Concerns with stressed input tests in Annex 120G 8023ck_D1p3 V2

John Calvin, Hadrien Louchet, Varun Garg

2020.10.26

IEEE 802.3ck Receiver Input Test

Impact of SJ

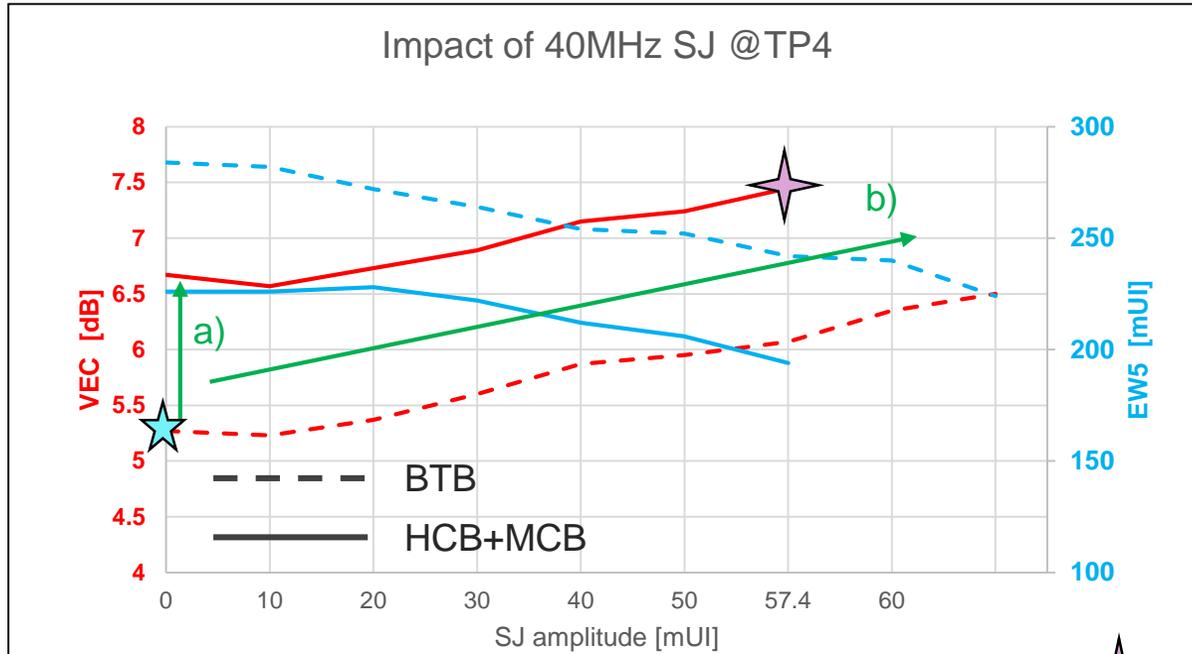
S4p @ 26.56 GHz	Performance with and <i>without</i> 50mUI SJ @ 40MHz					
	SD21/SD11 [dB]	VEC dB	VEC dB	EW [mUI]	EW [mUI]	EH [mV]	EH [mV]
Cisco M8049A	-18/-19	8.81	7.2	168	212	20.4	24.7
ML+ M8049A	-18.6/-20	12.4	9.2	114	162	11.2	16.4
ML	-8/-17.5	8.3	6.9	194	238	29.6	35
Lim ¹	-14/-10	6.7	5	218	260	31	38
Tracy ²	-15/-16.5	7.9	6.5	194	244	27	32
Kocsis ³	-8/-8	9.7	7.6	168	212	49	62

- >1dB VEC penalty for near-end (<10dB)
- > 1.5dB VEC penalty far-end (>15dB)

Channels considered in previous presentation present worse performance than reference channels discussed in ^{1,2}

Impact of SJ

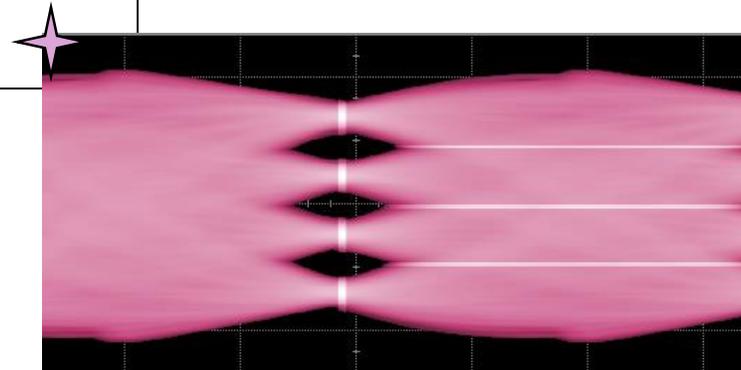
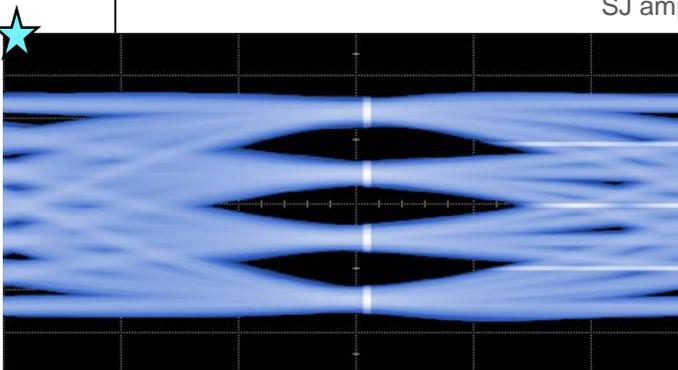
a) ~1dB VEC penalty for MCB-HCB vs BTB

- ✓ Can be reduced to xxx by using 9-taps FFE instead of DFE
- Limited impact of x-talk (~0.2dB)
- Limited de-emphasis accuracy (?)

b) 50mUI SJ → ~1dB VEC penalty

- SJ affects EW, EH and VEC
- Jitter-to-amplitude conversion
